NORTHEAST UTILITIES

Millstone Nuclear Power Station, Unit No. 3
Submittal of Draft Standard Technical Specifications

Northeast Nuclear Energy Company (NNECO) hereby submits draft Standard Technical Specifications (STS) for:

1. Three loop operation of Millstone Unit No. 3.
2. Revised draft STS to reflect ANSI N510-1980.
3. Revised draft STS that provide additional information not included in the original submittal.

Figure 2.1-1. Reactor Core Safety Limit — Four Loops in Operation

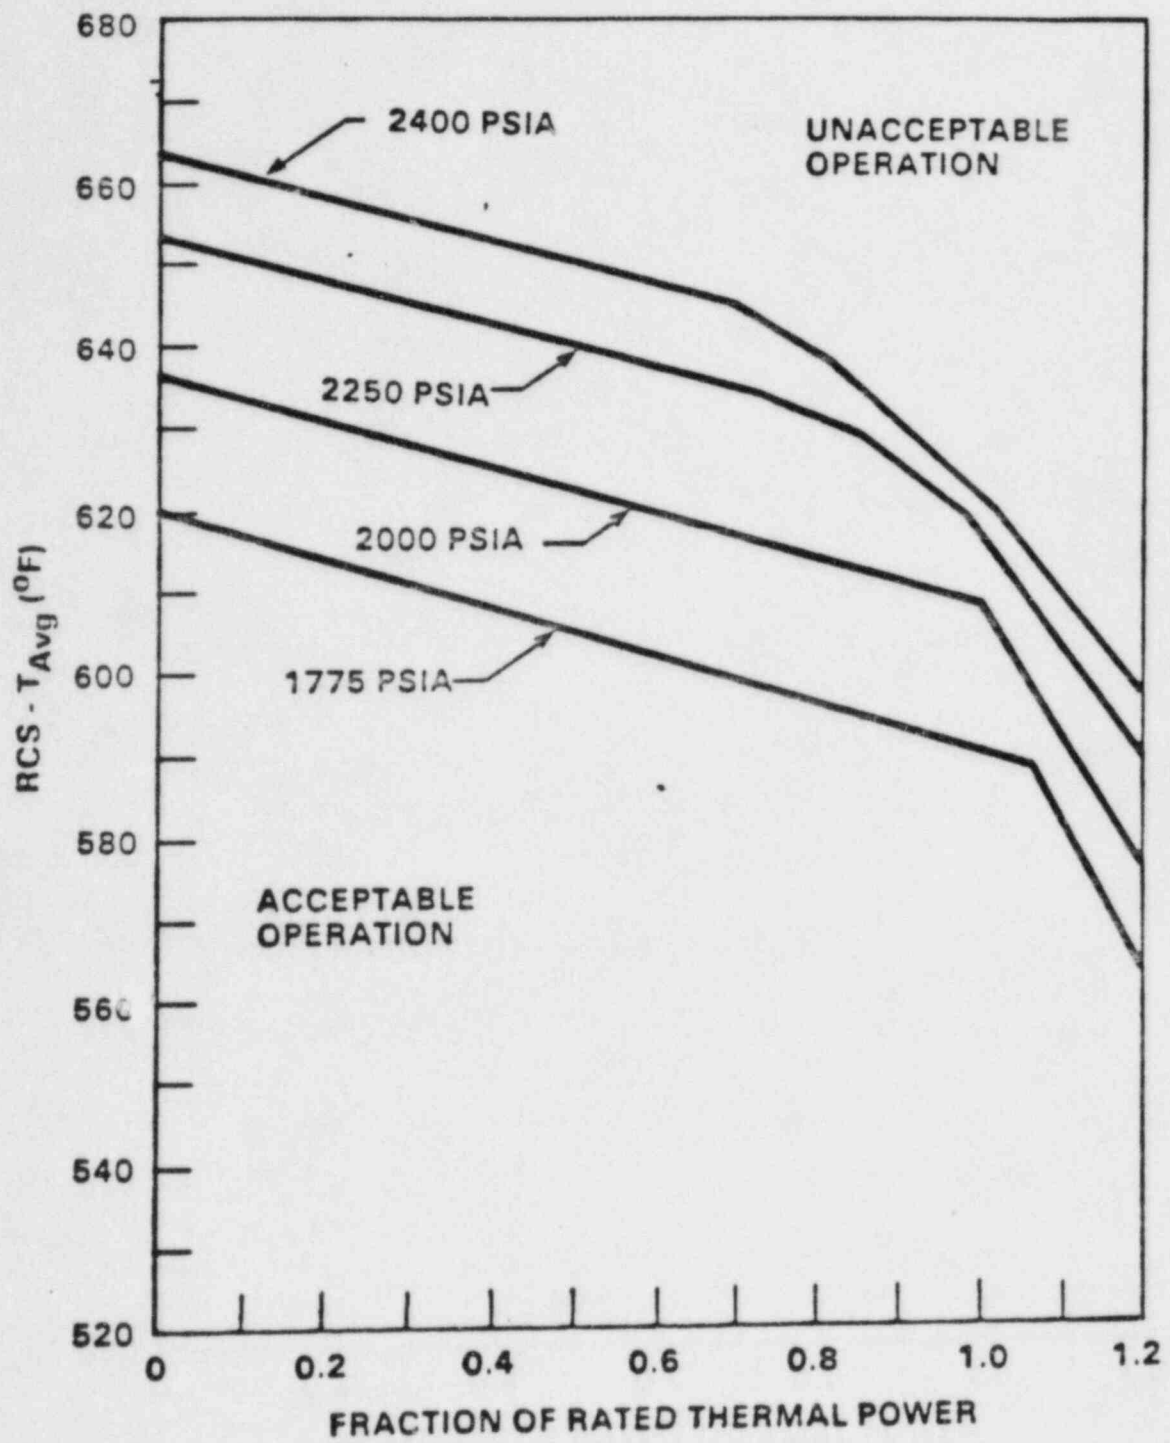
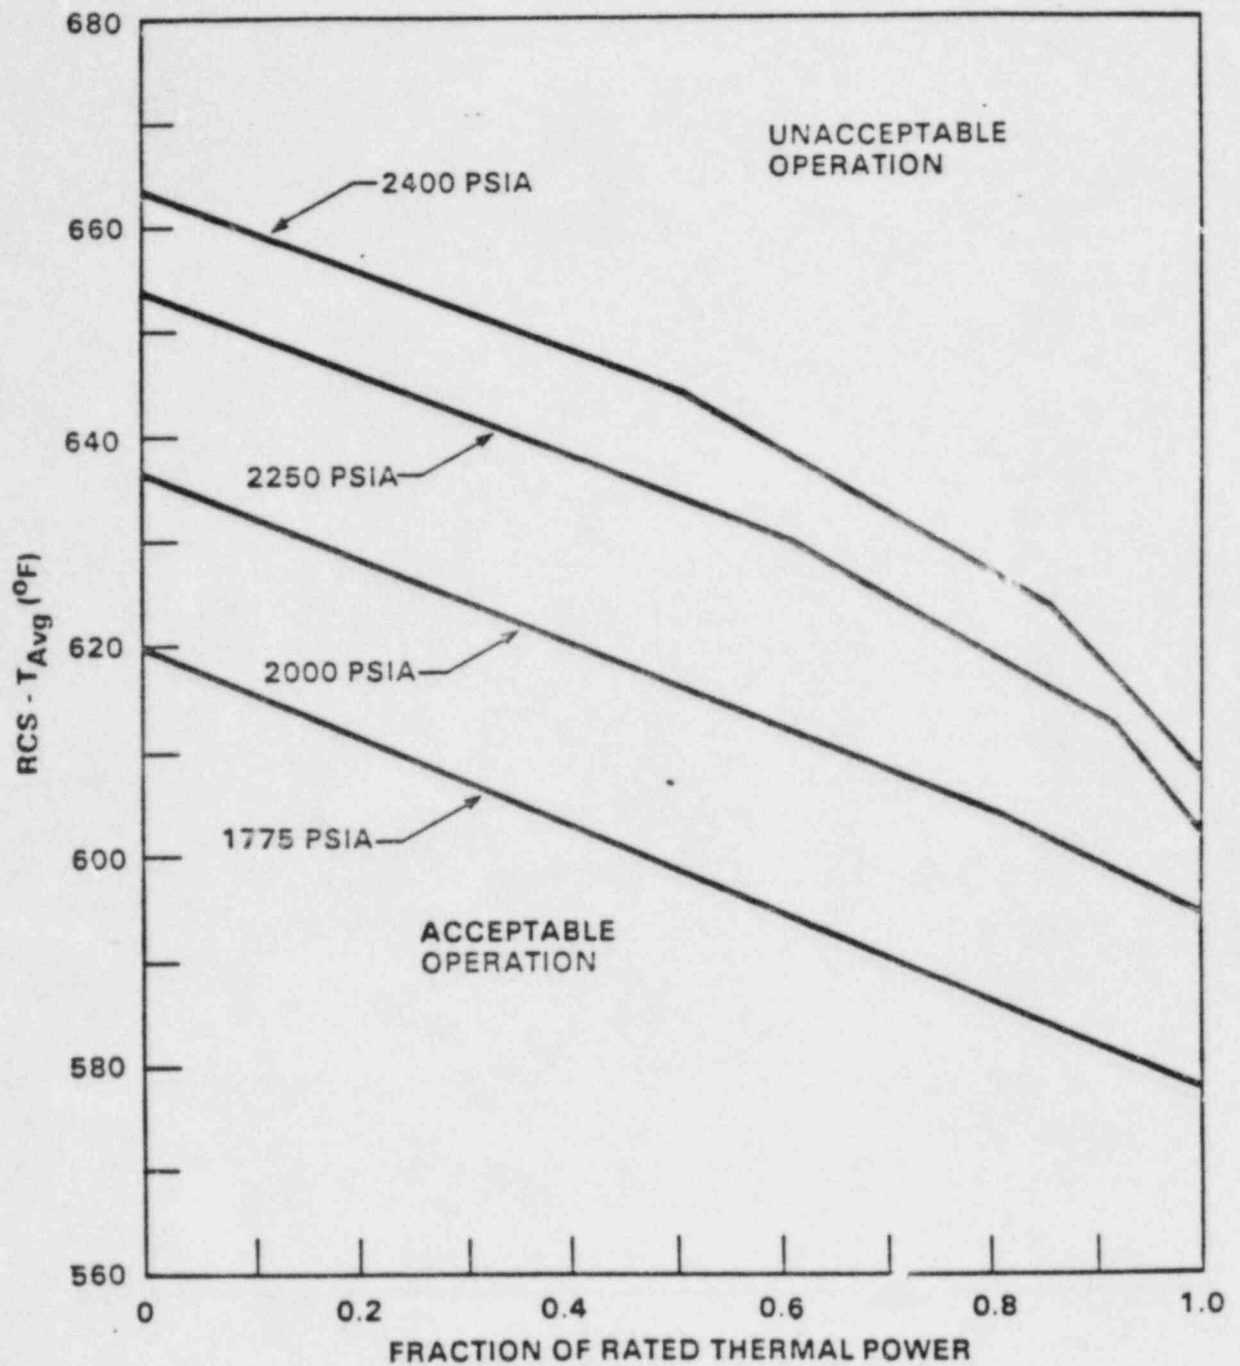
1. It was noted that this transmittal included a more legible copy of Figure 2.1-1 Reactor Core Safety Limit - Four Loops in Operation. The typographical error relating to the curves for 2250 PSIA and 2400 PSIA was corrected.
2. It was noted that the only difference from the draft specifications submitted to the NRC was the addition of Figure 2.1-2 Reactor Core Safety Limit - Three Loops in Operation as supplied by Westinghouse.

1. Added plant specific safety limit curve as supplied by Westinghouse.
2. Modified bases to reflect plant design, e. g. added "R-Grid" to W-3 DNB correlation and changed " $F_{\Delta H}^N = 1.55 \{1 + 0.2(1-P)\}$ " to " $F_{\Delta H}^N = 1.55 \{1 + 0.3(1-P)\}$."

FIGURE 3.1-2

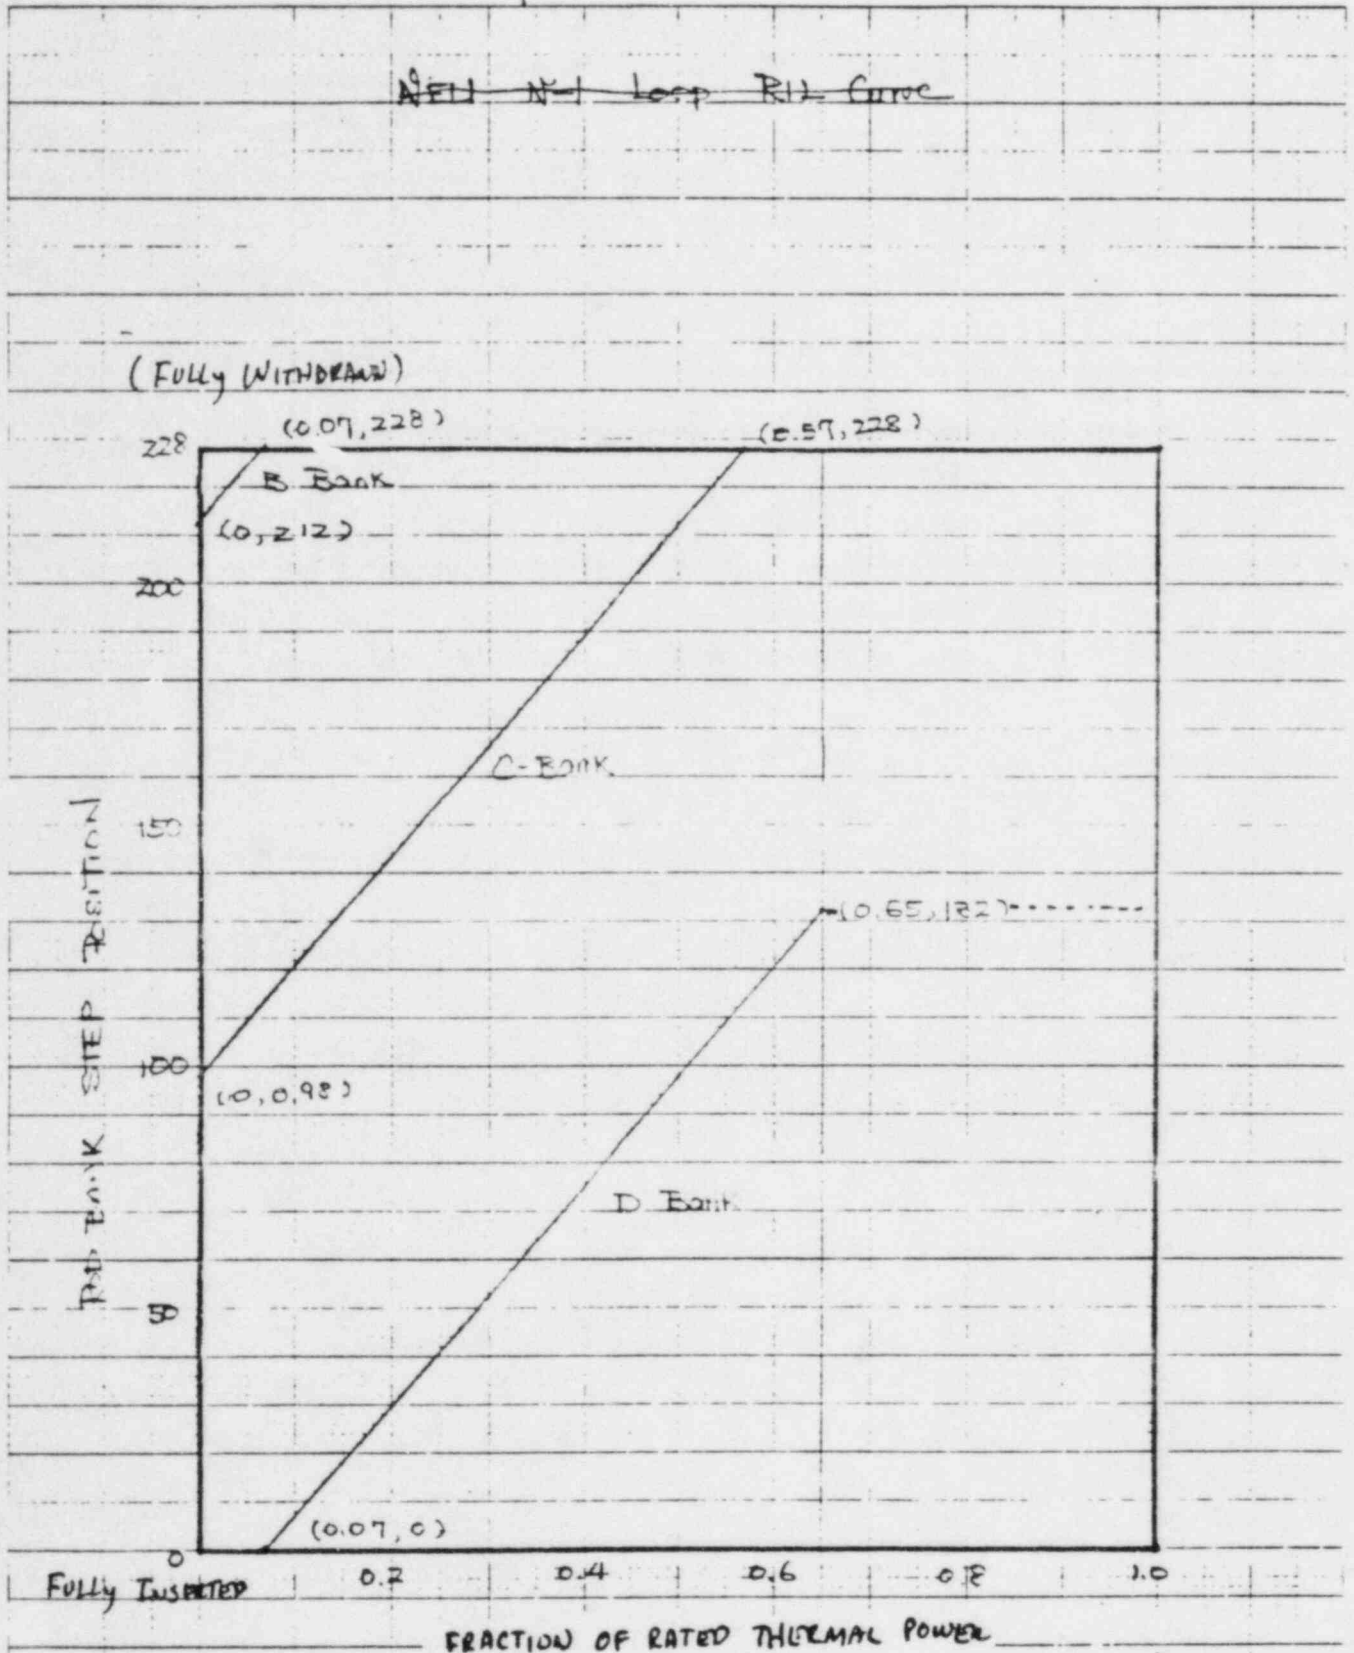
1. It was noted that the only difference from the draft specifications submitted to the NRC was the addition of Figure 3.1-2, Rod Bank Insertion Limits versus Thermal Power - Three Loop Operation.

FIGURE 3.2-1 *a* AXIAL FLUX DIFFERENCE LIMITS AS A FUNCTION OF RATED THERMAL POWER

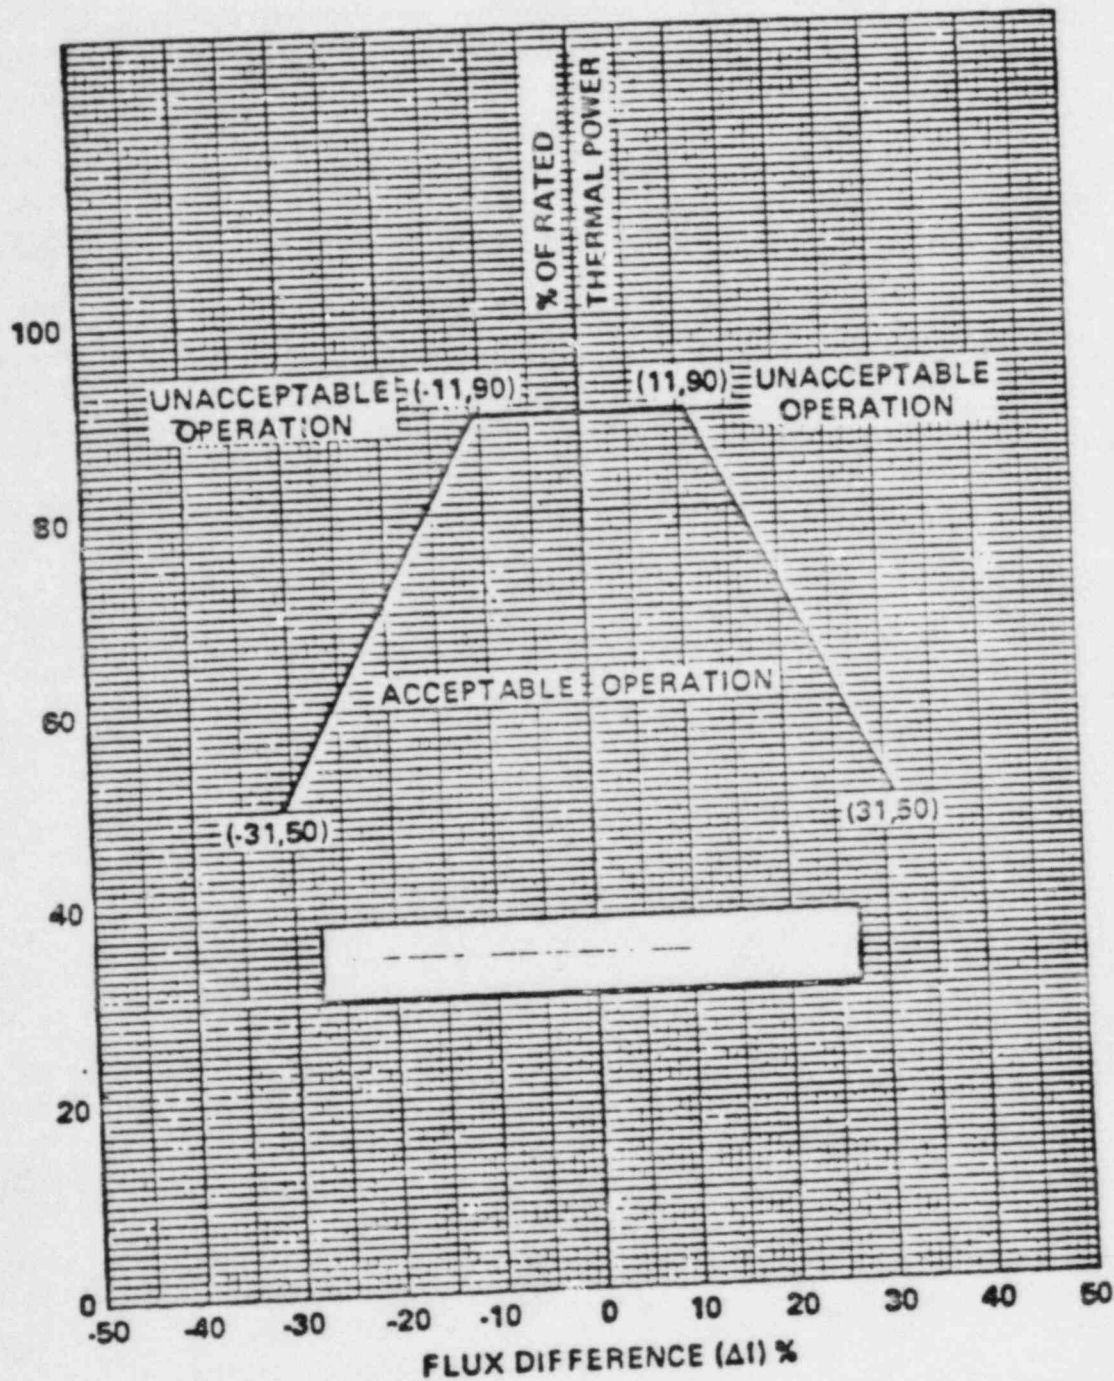
The indicated AFD may deviate outside the above required target band at greater than or equal to 50% but less than 90% of RATED THERMAL POWER provided the indicated AFD is within the Acceptable Operation Limits of Figure 3.2-1 2 and the cumulated penalty deviation time does not exceed 1 hour during the previous 24 hours.

32% The indicated AFD may deviate outside the above required target band at greater than or equal to ~~50%~~ but less than ~~90%~~ of RATED THERMAL POWER provided the indicated AFD is within the Acceptable Operation Limits of Figure 3.2-1^{65%} and the cumulated penalty deviation time does not exceed 1 hour during the previous 24 hours.

Figure 3.2-2

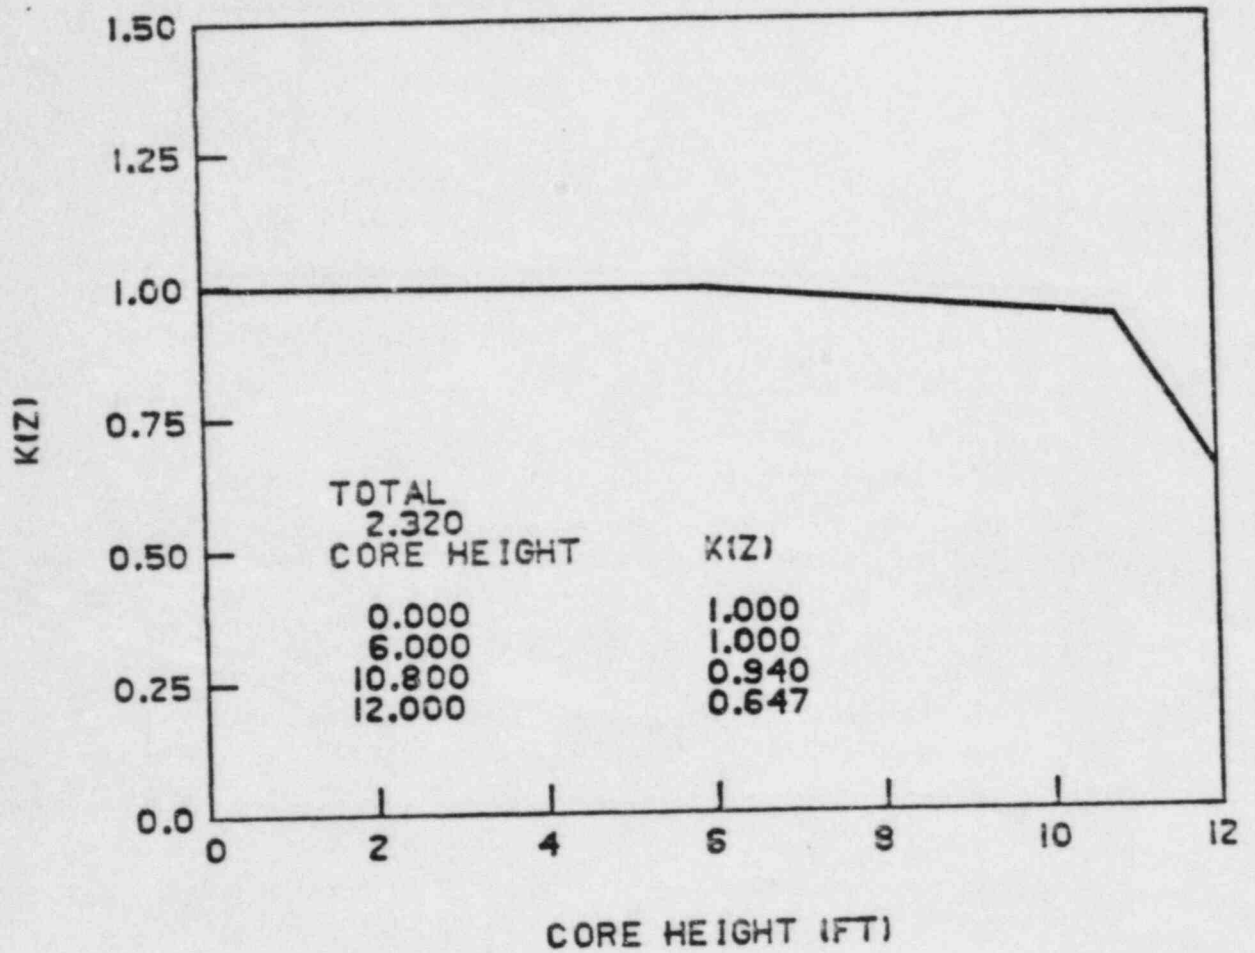
and $K(Z)$ is the function obtained from Figure (3.2-2) for a given core height location.

FIGURE 3.2-3 RCS TOTAL FLOWRATE VERSUS R — FOUR LOOPS IN OPERATION

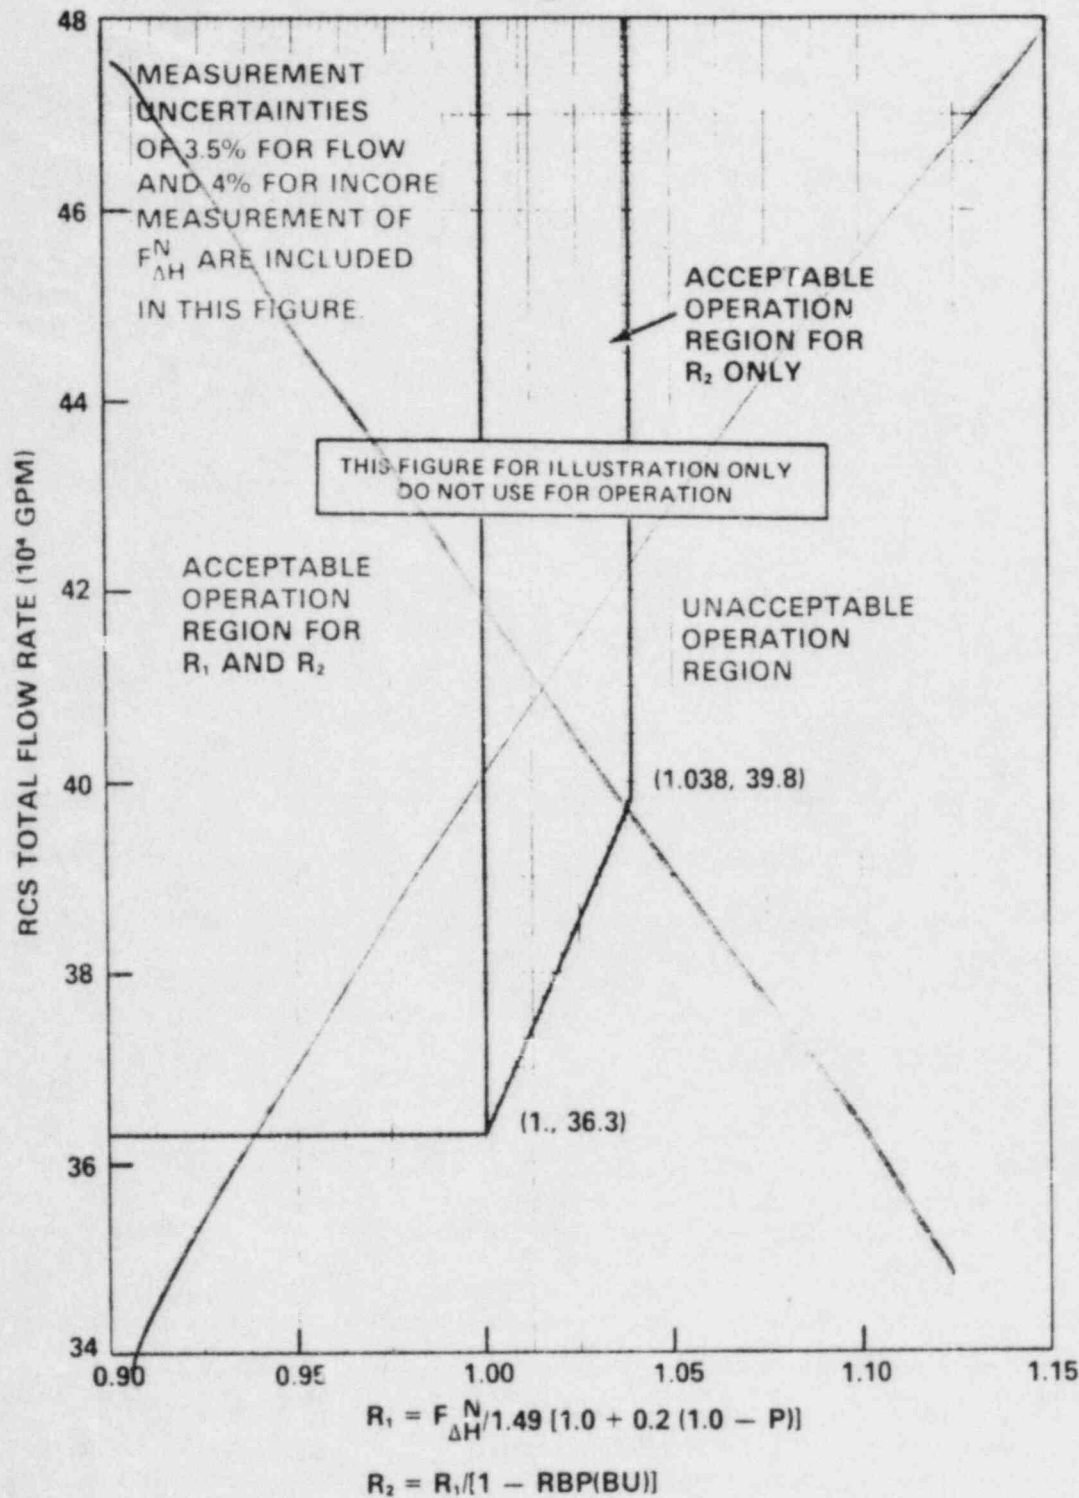
1. Deleted references to R_2 and the ROD BOW PENALTY to be consistent with the FSAR and incorporate recommendations made by Westinghouse.
2. The 2.1% flow uncertainty for flow in Figure 3.2-3 may change as a result of analysis being done in response to NRC Question 492.7.

3. Deleted Figure 3.2-3 and its factor to make the specification read $F_{OH} \leq$ and RCS flow \geq

Delete
